Access Design Review

From:	McKenzie Access c/o Angela Chambers
Date:	17-03-23 Design Assessment 02-05-23 Updated
Project:	213119 Freshwater SLSC Redevelopment Works
Subject:	Accessibility Review – DA Documentation

Refer Appendix A for marked up drawing – Level 1 & 2 Floor Plan.

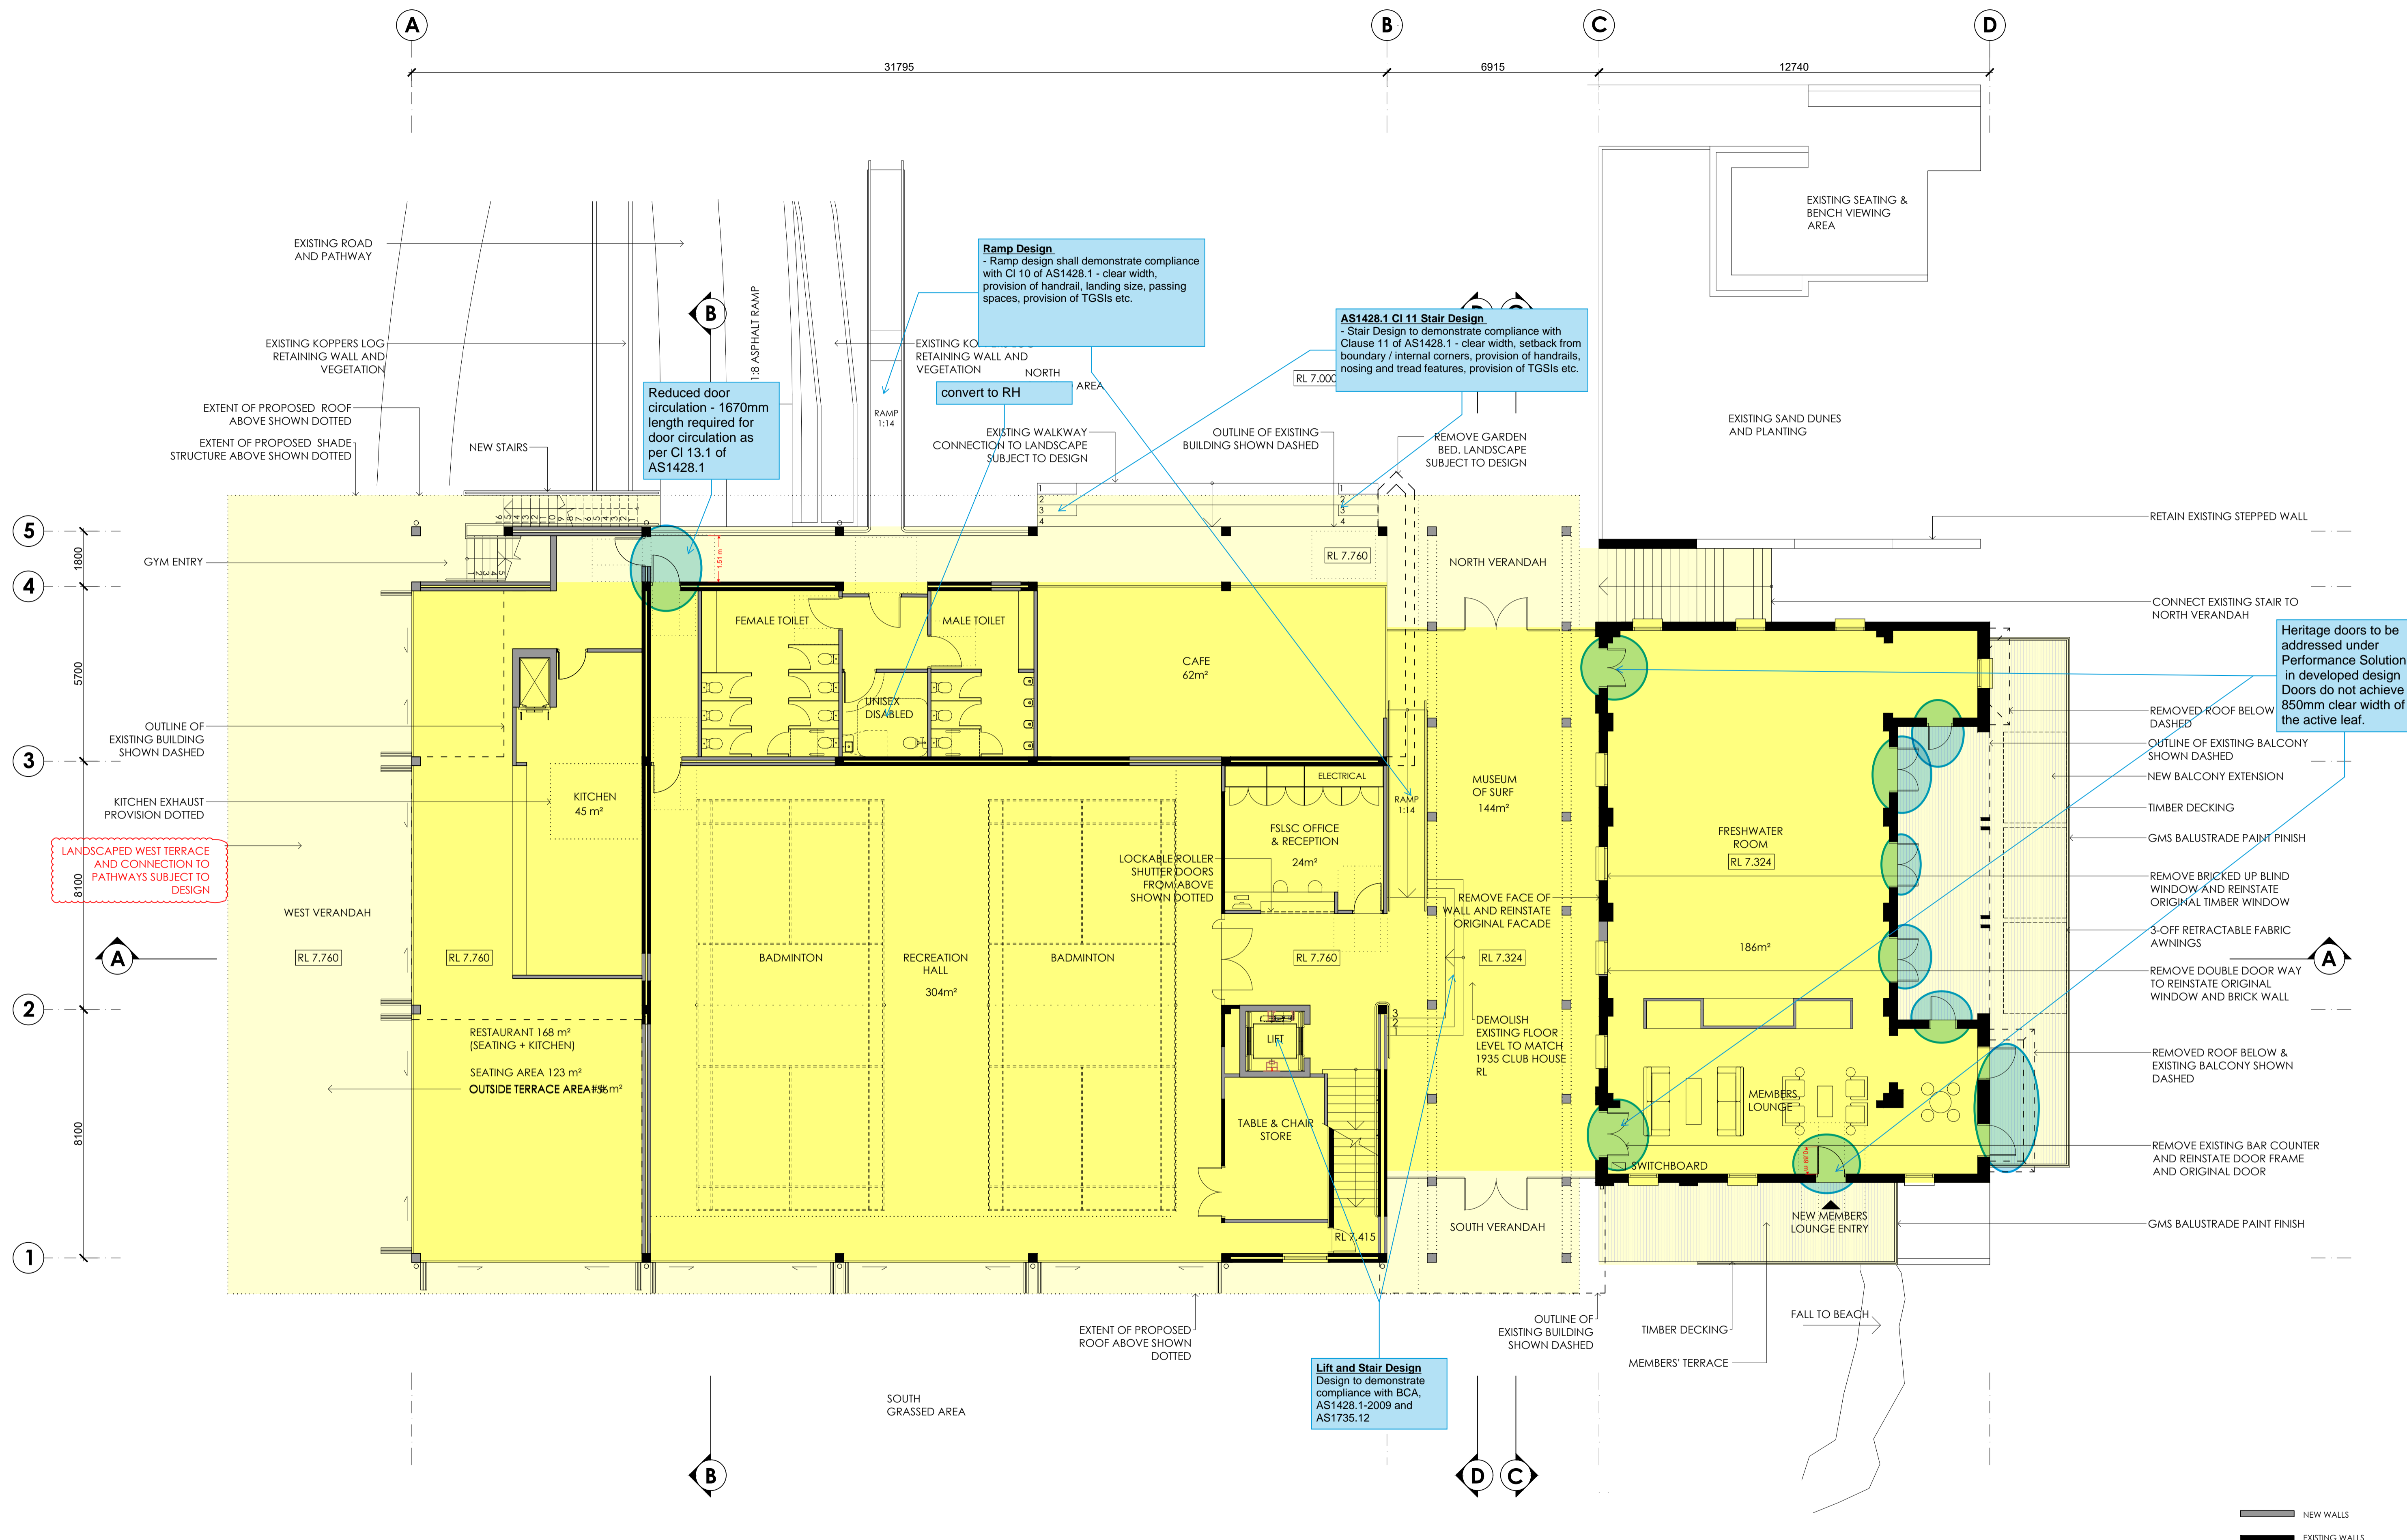
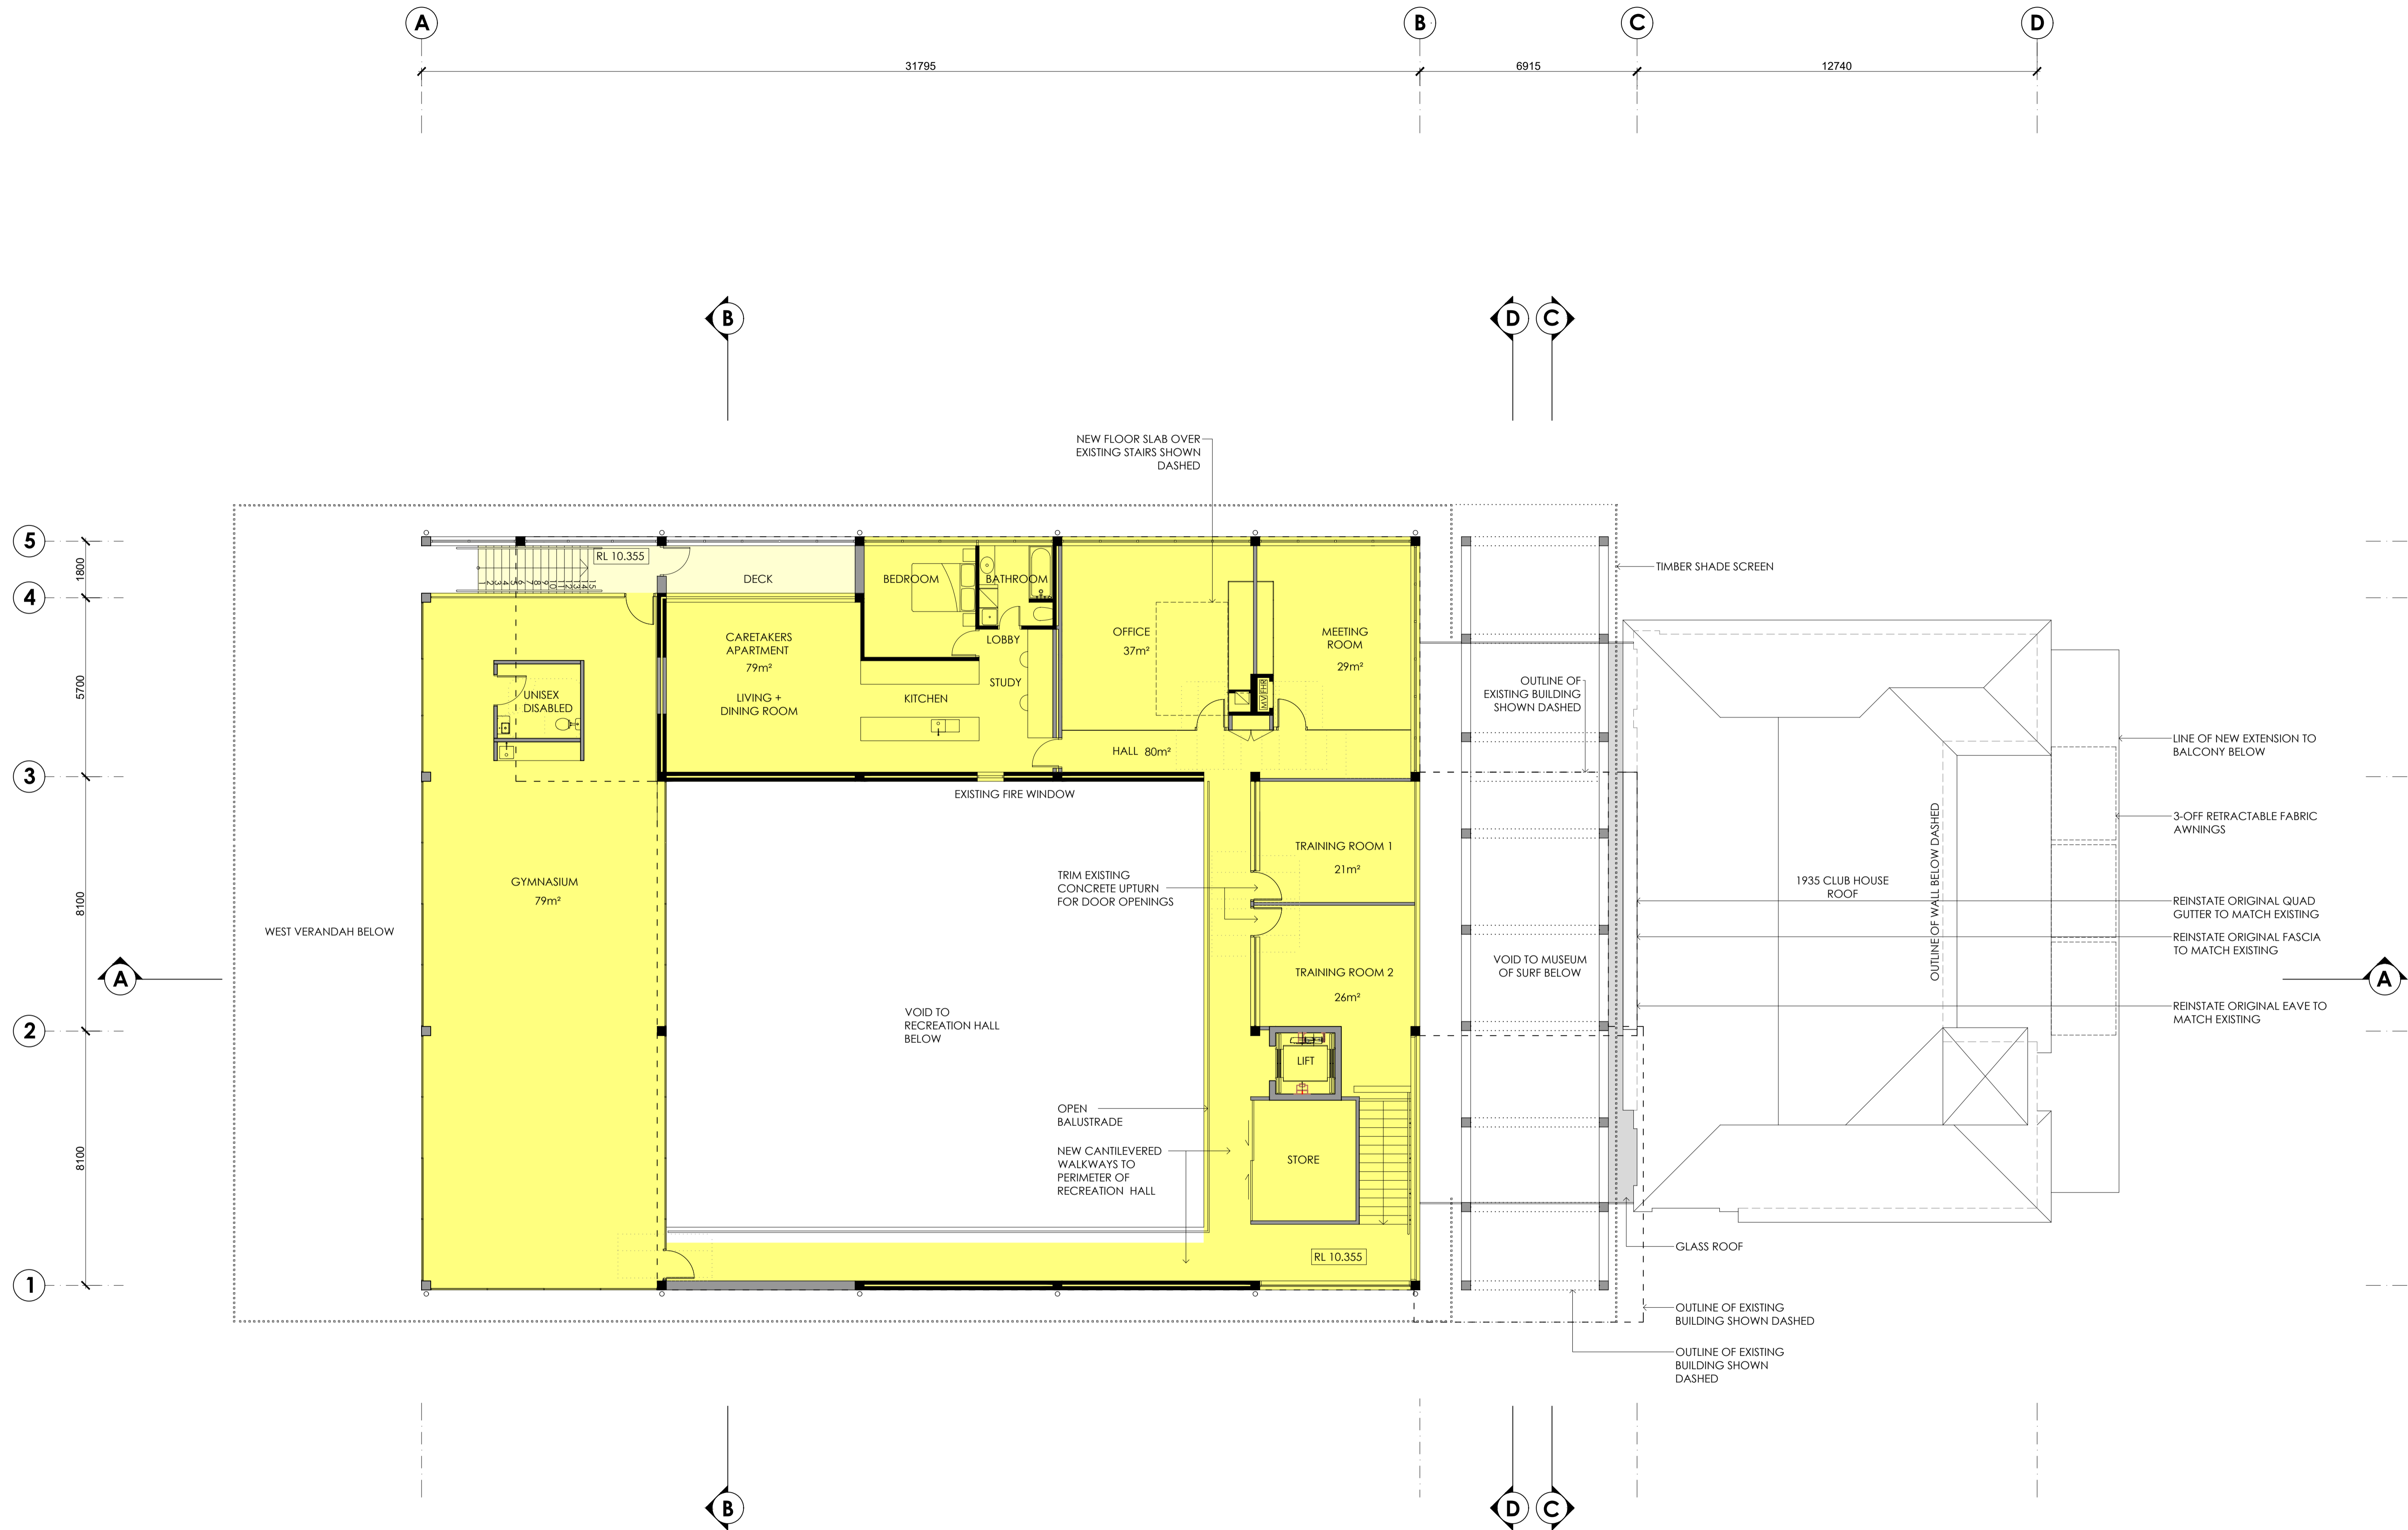
Item	BCA Clause	Relevant Performance Requirements	Technical Requirement	Technical Departure
1.	D4D2 (6)	D2D1	BCA Part D4D2 (6) requires, for Class 5, 6, 7b 9b buildings, access must be provided to and within all areas normally used by the occupants.	Existing heritage doors on level 2 contain technical departures and will require an operational solution to ensure ease of access through the openings. Doors do not achieve 850mm clear opening of active leaf. Doors to be held in the open position during normal occupation.

2.	F4D6 (1) (d)	F4P1	BCA Part F4D6 requires, where required by F4D5(a), the minimum number of Accessible Unisex Sanitary Compartments for Class 5/9b building are required to be provided: <ul style="list-style-type: none"> i. 1 on every storey containing sanitary compartments, and ii. Where a storey has more than 1 bank, 50% of the banks 	An Accessible Unisex Sanitary Facility (UASF) is not provided on level 1 change areas / showers. Omission of a UASF on a storey containing Sanitary Facilities is not in accordance with the DtS Provisions of the BCA.

11.	<u>Unisex Accessible Sanitary facilities (UASF)</u>	<p>Unisex accessible sanitary facilities are to be installed as per F2.3/F2.4 and AS 1428.1-2009</p> <ul style="list-style-type: none"> ▪ UASF to be provided on each level where one or more toilets are provided ▪ Required at 50% of the banks of the toilets on each level ▪ Provide an equal distribution of Left hand (LH) & right hand (RH) toilets / showers (staggering throughout levels is preferred) <p>Design to comply with Clause 15 AS1428.1-2009:</p> <ul style="list-style-type: none"> ▪ Combined WC and basin minimum of 1900x2630mm (based upon 430mm basin depth) (Refer Fig 43) ▪ Combined WC and shower facility: 2300x2630mm (based upon 430mm basin depth) (Refer Fig 50) <ul style="list-style-type: none"> ○ Refer to Figure 50 of AS1428.1 for required compartment size and layout of fixtures and fittings. 	<p>UASF - Located on Level 2 & 3</p> <ul style="list-style-type: none"> ▪ Developed Design to demonstrate Compliance ▪ Convert level 2 to RH layout ▪ Performance Solution <p>A performance solution will be required to address the lack of accessible toilet on Level 1.</p>

Item	Element	Item for Review	Action Required
BCA Compliance - Mandatory			
12.	<u>Ambulant Cubicles</u>	Male and Female Ambulant Cubicles are required on each level where gender facilities are provided in addition to UASF Design to comply with Clause 16 of AS1428.1-2009	Annotate ambulant cubicles <ul style="list-style-type: none"> ▪ Developed Design to demonstrate Compliance There are separate male and female ambulant facilities on levels 1 & 2.
